RWE Renewables UK Solar and Storage Limited ("RWE")

Proposed Peartree Hill Solar Farm Order (the "Proposed Development" and the proposed "Order")

Written Representation (Objection) on behalf of Albanwise Limited (Interested Party Reference PHSF-AFP001), Albanwise Synergy Limited, Albanwise Farming Limited, and Field House Renewables Limited¹, collectively ("Albanwise") (Interested Party Reference [REDACTED]) in relation to RWE's change request application submitted to the Planning Inspectorate on 10 September 2025 ("Change Request 9 Application" [REP2-149] setting out "Proposed Provisions") and accepted by the Examining Authority, as confirmed by letter dated 19 September 2025

Figure 4 RWE Swept Path (with hatching removed for clarity)

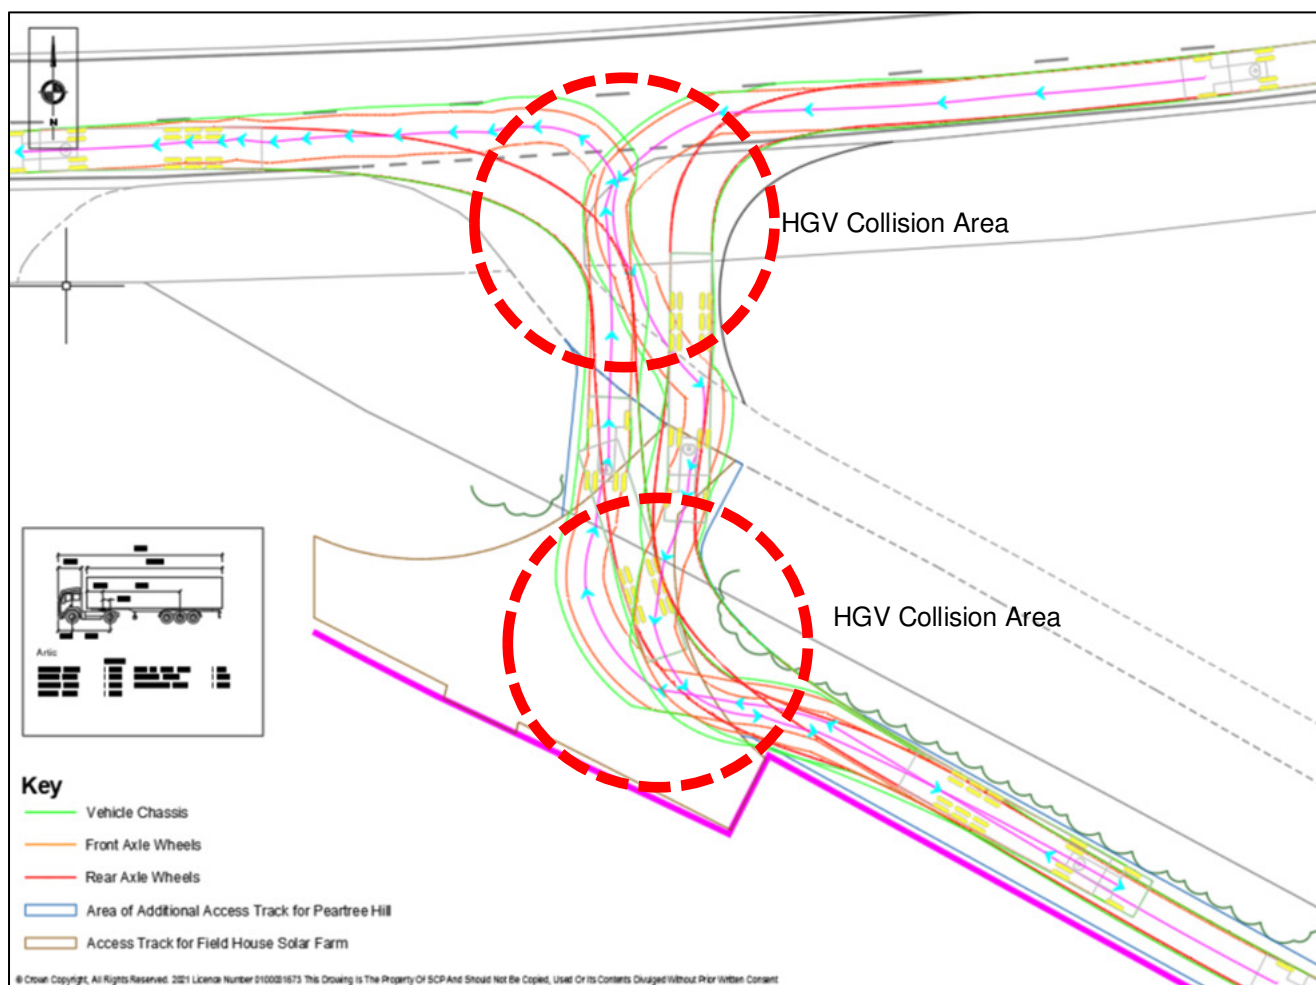
RWE have proposed junction modifications to accommodate their proposed construction vehicle movements, although all works are based on OS mapping, rather than a topographical survey.

The tracking drawing clearly indicates two locations where two-way traffic operation is not possible (circled), and where the vehicles will come into conflict. This will require loads to travel at very slow speed and that traffic will need to be held to pass in safety.

Figure 5 RWE Proposed Passing Place Locations

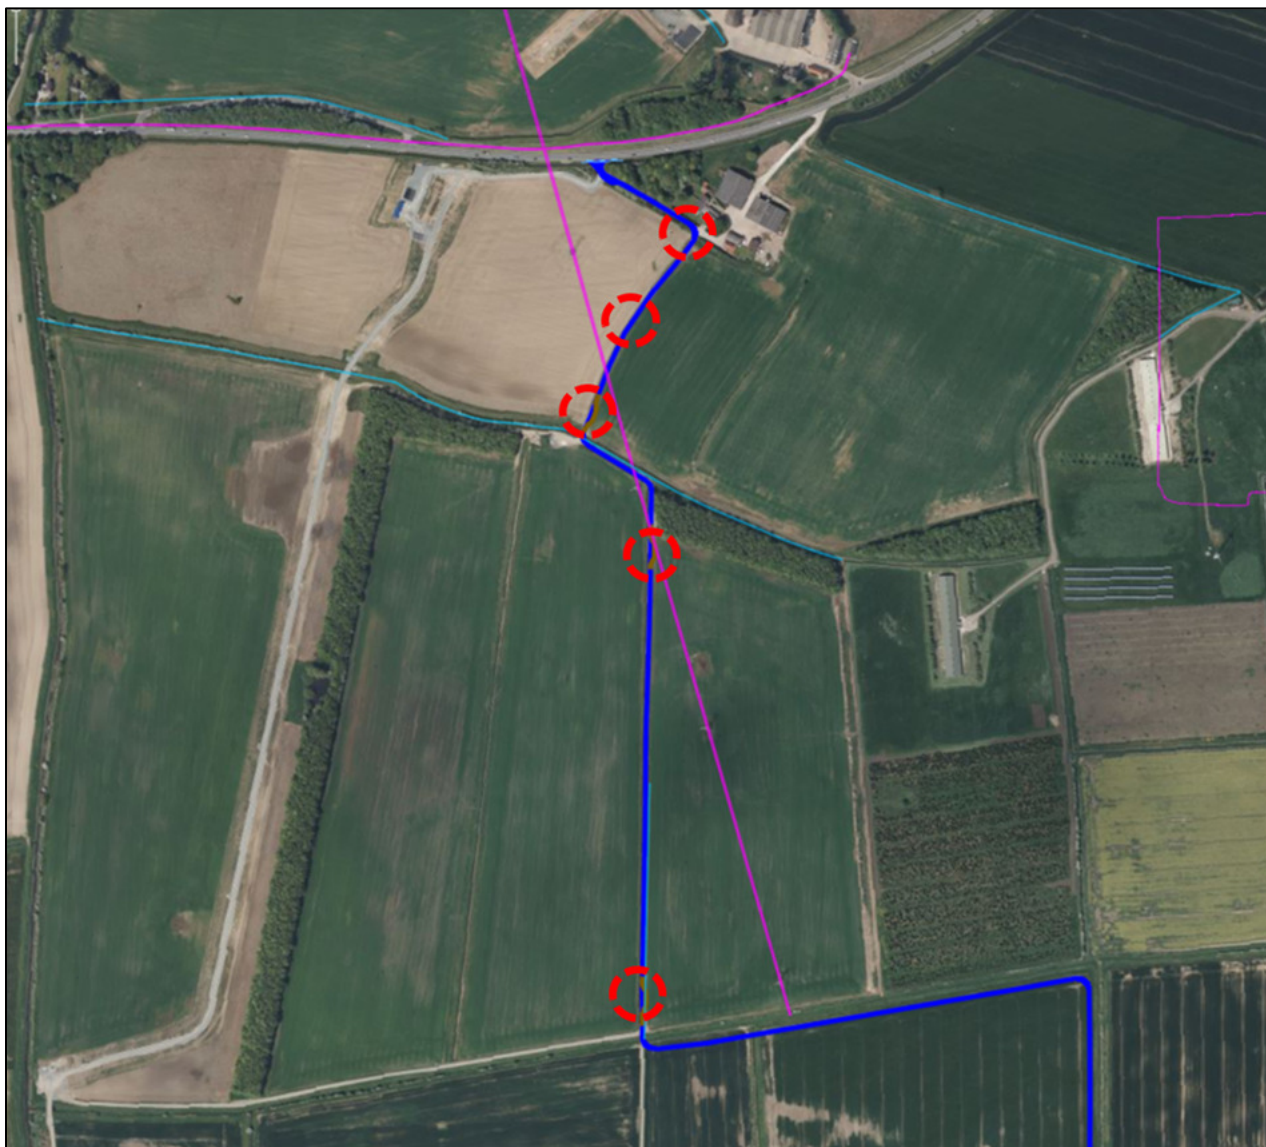
Albanwise welcomes the suggested passing places, proposed following the Change 9 submission as a means of managing Proposed Development construction traffic and agricultural traffic on the access track network. No set dimensions of this and of the other passing places are however provided. These details are required to clarify that the proposed works are suitable to accommodate the safe and efficient two-way traffic flows, without unnecessarily using too much agricultural land. A review of the AutoCAD plan provided by RWE's consultants suggests that the proposed width is 8.83m, in excess of the more normal passing place width of 6m.

Figure 6 RWE Swept Path drawing at the Junction Bend

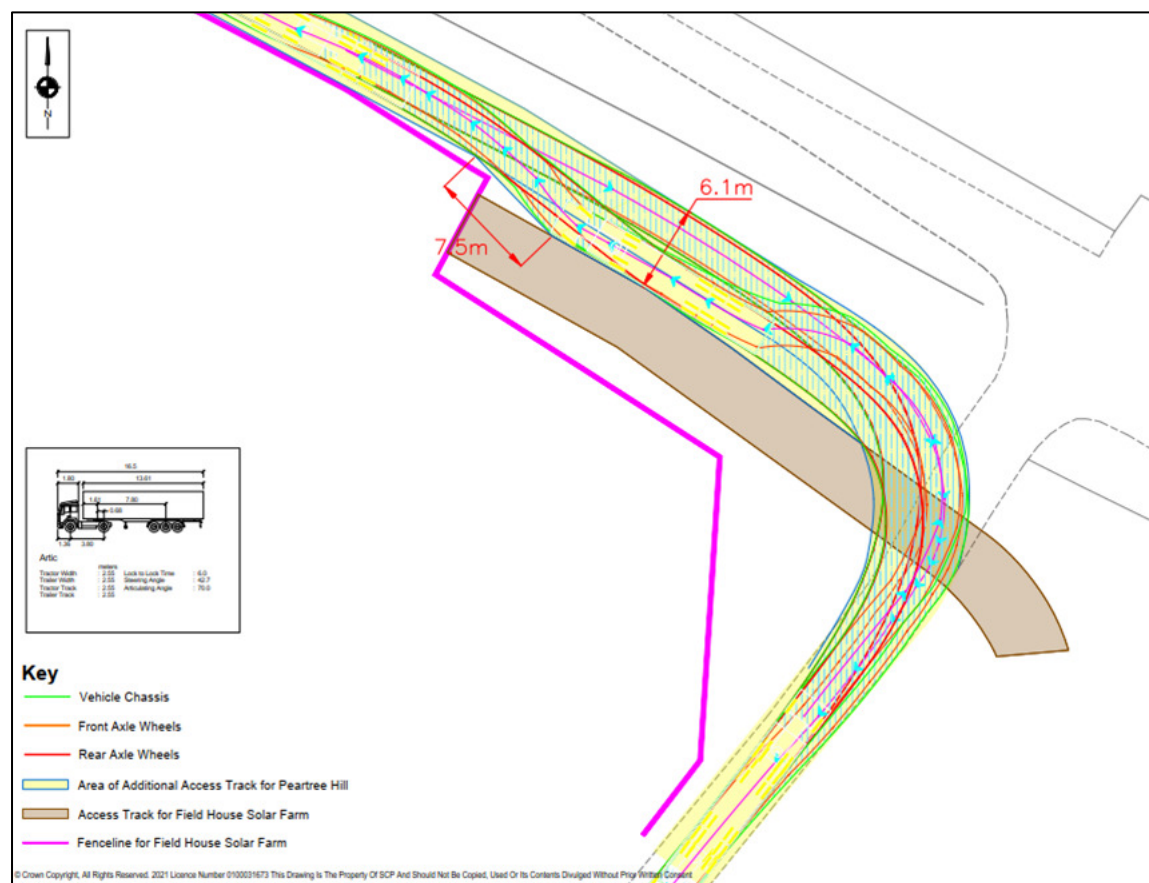
The provision of a priority system at this bend, illustrated in further detail in Figure 6, would be simple to install, consisting of “Give Way” signage and possible markings. Given these measures are commonplace across the wider public road network, it is surprising that RWE are adopting their stated position.

The layout in Figure 6 provides no lateral separation between the Field House access track (coloured brown) and the RWE proposals (coloured yellow). Three HGV can conceivably pass at this location, one for Field House Solar Farm heading east, one for the Proposed Development heading west and one for the Proposed Development heading south. This is substantial conflict point and is again highly constrained. A priority system here would help manage the competing traffic.

The design of the bend passing area is an improvement from earlier iterations, however, further design work consideration would present an improved solution at this key location. If banksmen are to be provided at this location, further detail is required to illustrate the location of their position and associated welfare facilities.

Figure 7 Typical Crane Details

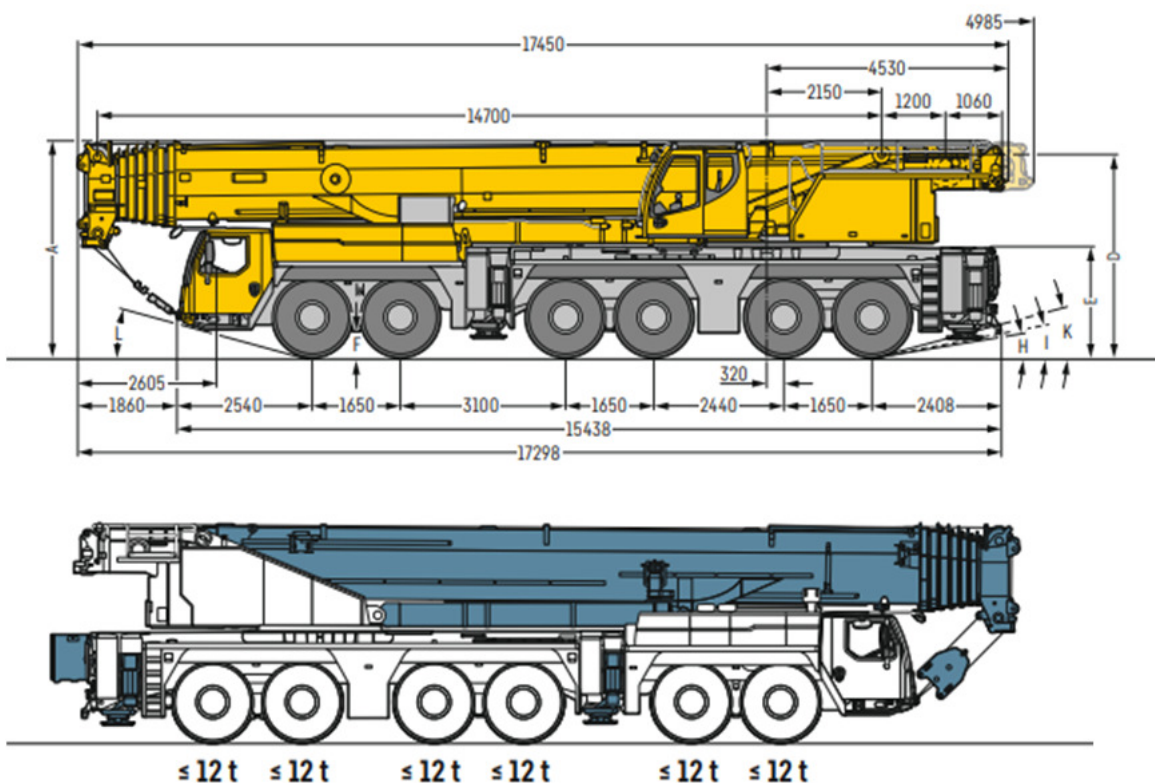
In addition to the transformer vehicle, it would seem reasonable that a mobile crane would be required to access the site in order to position the transformer. A typical 300tonne capacity crane¹ is illustrated in Figure 7 which, in Pell Frischmann's opinion, could be used for this purpose.

At 12 tonnes axle loads, these are heavier than the suggested AIL vehicle proposed by RWE and would need to be considered when reviewing the suitability of existing culverts. There additionally appears to be a watercourse crossing (and field boundary drain) at the eastern end of the parcel 6-7 east-west track which has not been accommodated for in the project designs.
